<b>Company</b>	Trenz Electronic GmbH
<b>Number</b>	AVN-20211202
<b>Title</b>	Problematic MEMS Oscillator
<b>Subject</b>	Information and remedy concerning problematic MEMS Oscillator
<b>Issue Date</b>	2021-12-09

possibly affected	not affected
DSC6111MI2A-025.0000	SiT8008BI-73-18S-25.000000E

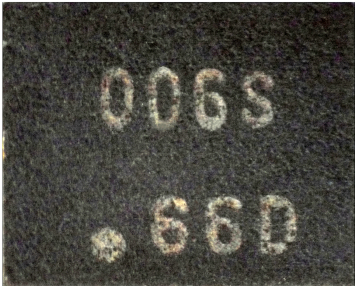
Due to component shortage from June to August 2021 some Trenz Electronic products were assembled with datasheet compatible DSC6111MI2A-025.0000 instead of SiT8008BI-73-18S-25.000000E. Although there is no evidence for any performance issues from the datasheets at least one batch of DSC6111MI2A-025.0000 has been identified to be root of issues in specific applications.

1. Ethernet communication with online available standard reference design is unreliably:
  - a. Standard ping test in separated environment results in package loss of up to 10% or
  - b. unexpected link up/down switches.
2. MGT communication fails, known to work designs showed no link.

If a Trenz Product shows one of the issues described above and the assembled MEMS oscillator is identified as DSC6111MI2A-025.0000 (see Method of Identification) please contact Trenz Electronic (see Contact Information). Please send the serial number of the affected product and choose one of the possible solutions below:

1. Trenz Electronic opens a RMA and the affected MEMS is replaced at Trenz Electronic.
2. Trenz Electronic sends a SiT8008BI-73-18S-25.000000E for substitution to the customer.
